JUN 26 1988  
L-86-241

Re: Turkey Point Units 3 and 4  
Docket Nos. 50-250 and 50-251  
NUREG-0737, Item II.D.1  
Performance Testing of Relief and Safety Valves -  
Request for Additional Information  
NRC TAC Nos. 44626 and 44627

## NRC REQUEST FOR ADDITIONAL INFORMATION

### PERFORMANCE TESTING OF RELIEF AND SAFETY VALVES

FIGURE 3

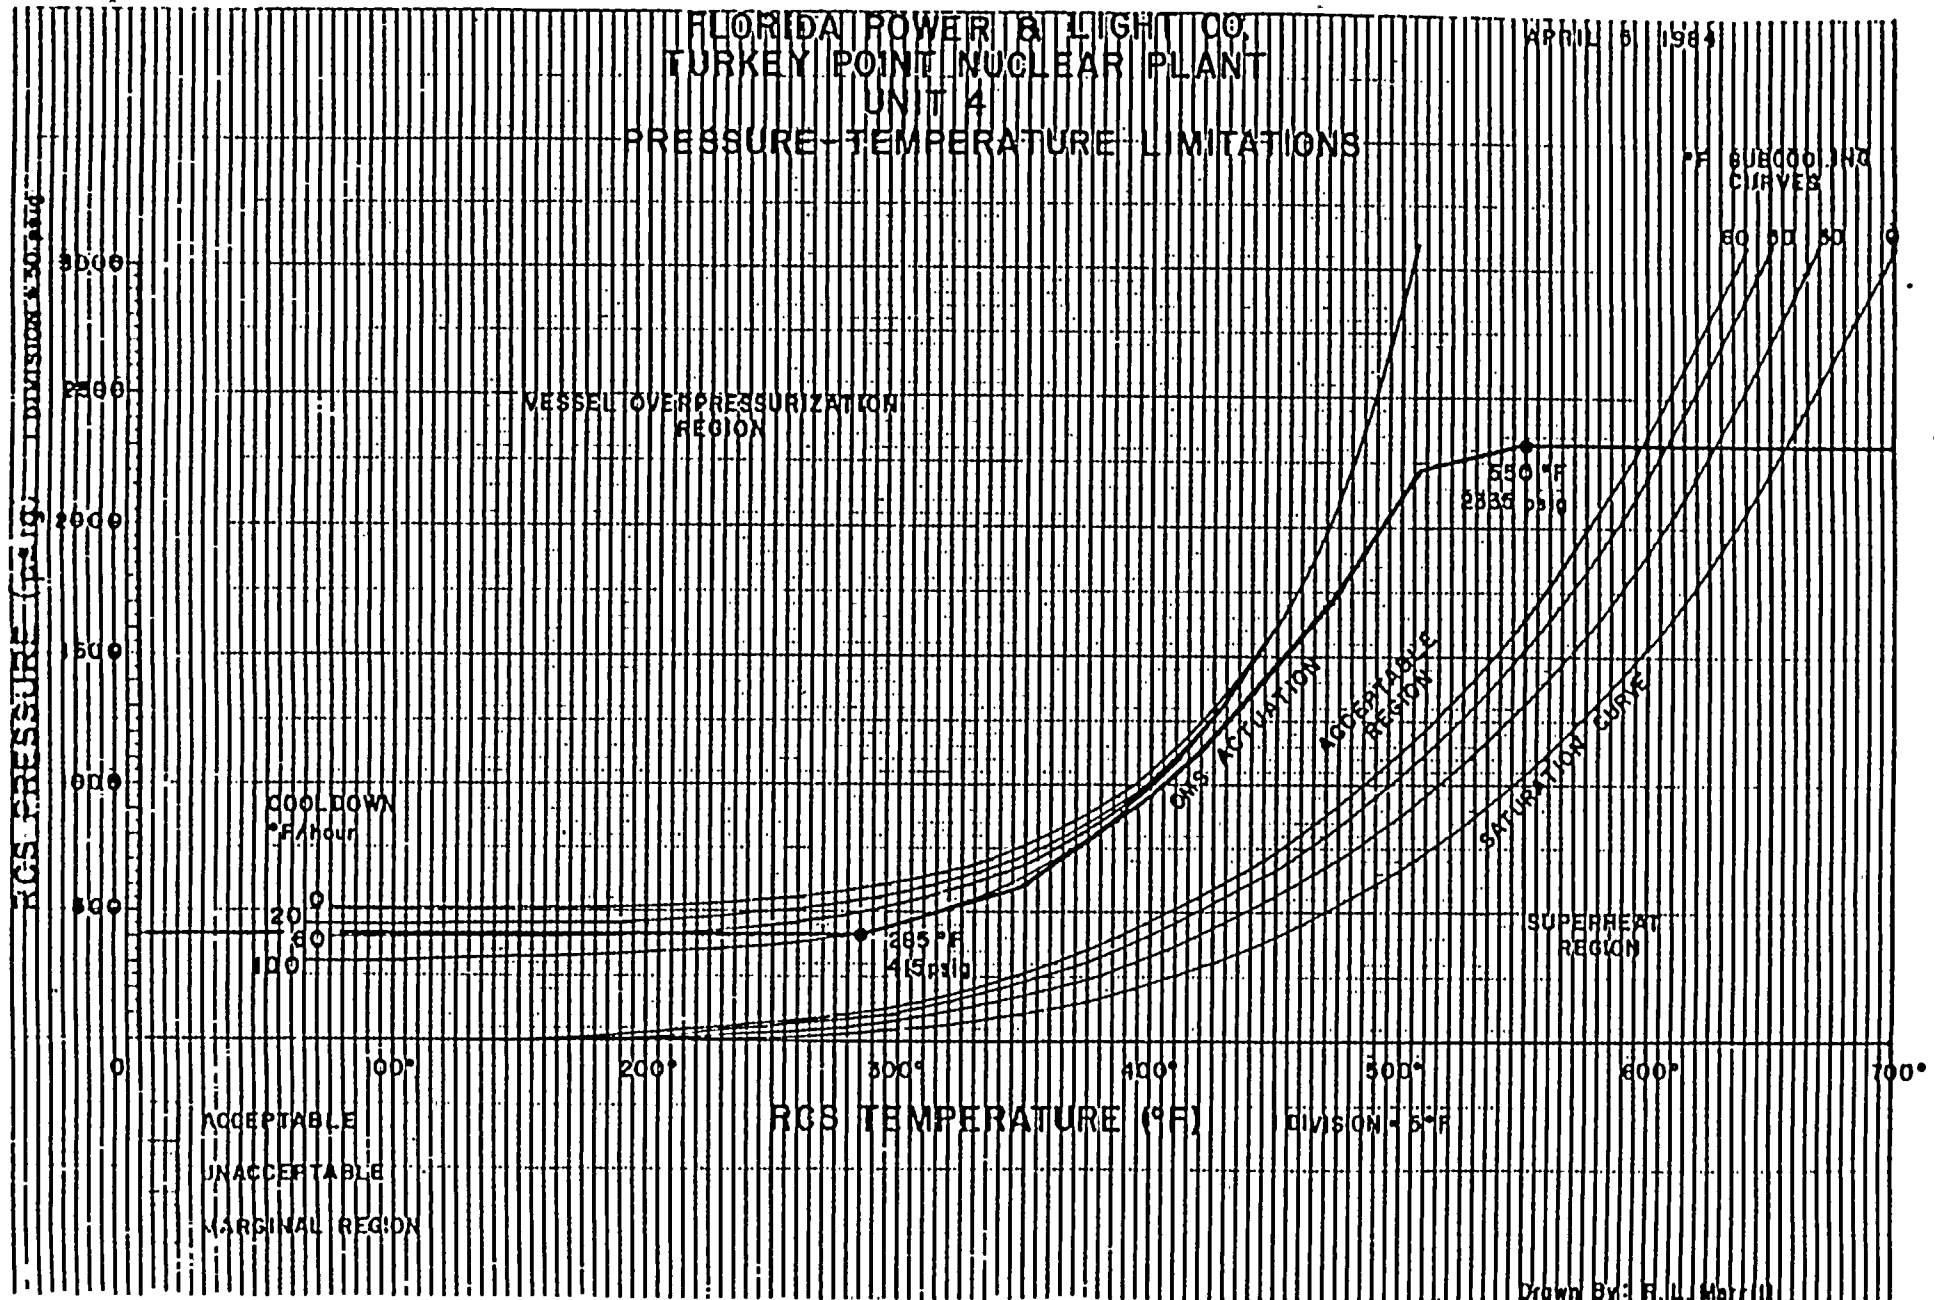
The submittal states that the inlet piping configuration in which the test safety valve was tested was similar to that of the Turkey Point safety valve system. It does not, however, provide a comparison between the inlet piping configurations to verify this statement. Therefore, provide a comparison between the inlet piping systems used in the tests and the plant. As part of this comparison, the two inlet piping pressure drops should be compared. Provide a numerical comparison between the calculated plant pressure drop and the test pressure drop and explain how the plant pressure drop was calculated.

Data shown is from "EPRI PWR Safety and Relief Valve Test Program Guide for Applications of Valve Test Program Results to Plant Specific Evaluations", REv. 2, Interim Report, July 1982 (VI02) Tables B-3 and B-7.

See Figure 3 for an illustration of the EPRI configuration.
